NEF-11 lbdh
94V-063

NHTSA Recall Campaign ID Number: 94V-063
(Please refer to this number in all future correspondence.)

BULLETIN NO
94-003

RECALL: Automatic Transmission Shift Linkage

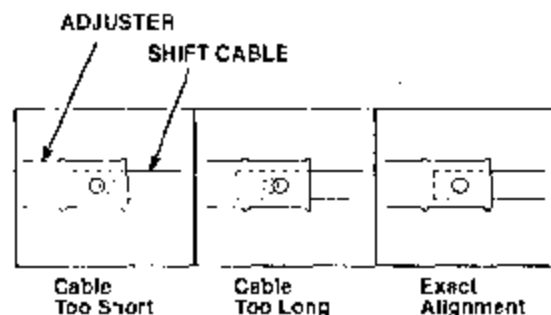
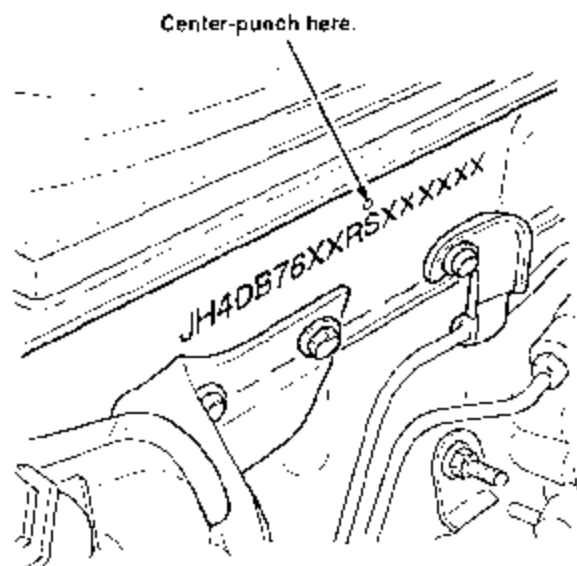
Replace the transmission shift linkage adjuster pin with the new part listed under PARTS INFORMATION.

3. Remove the adjuster pin from the shift linkage and discard it.

4. Install the new adjuster pin.
 - If the pin feels like it is binding, continue to step 5 to check the shift linkage adjustment.
 - If the pin fits without binding, go to step 6.

5. Remove the adjuster pin. If the holes in the shift cable and the adjuster are not perfectly aligned, loosen the locknut and turn the adjuster to align the holes. Tighten the locknut and reinstall the adjuster pin.

Adjuster pin: P/N 54363-689-981

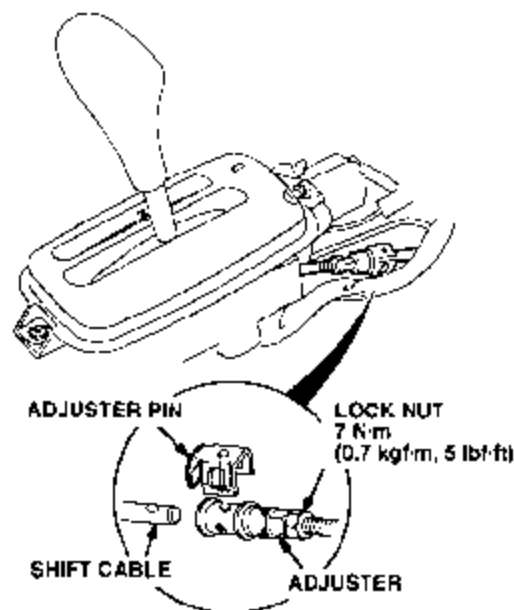
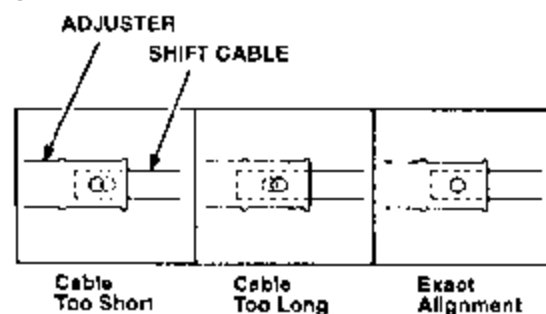
Replace the transmission shift linkage adjuster pin with the new part listed under PARTS INFORMATION.

1. Remove the center console. Refer to section 20 of the appropriate service manual for the proper procedure.
2. Move the transmission selector lever to Neutral.
3. Remove the adjuster pin from the shift linkage and discard it.

4. Install the new adjuster pin.
 - If the pin feels like it is binding, continue to step 5 to check the shift linkage adjustment.
 - If the pin fits without binding, go to step 6.
5. Remove the adjuster pin. If the holes in the shift cable and adjuster are not perfectly aligned, loosen the locknut and turn the adjuster to align the holes. Tighten the locknut and reinstall the adjuster pin.

P/N 54363-689-981, H/C 0933697

Make a center-punch mark above eleventh character.

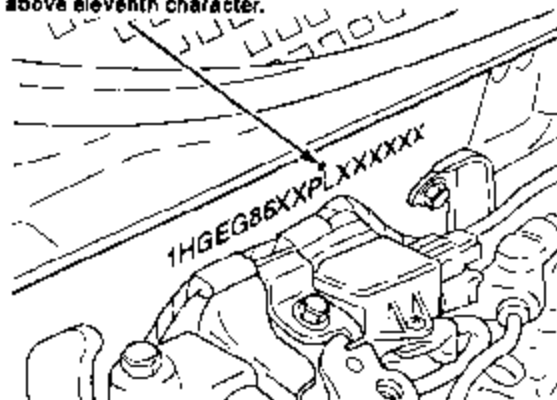
8. Center-punch a completion mark above the eleventh character (H, L, or S) of the engine compartment VIN.
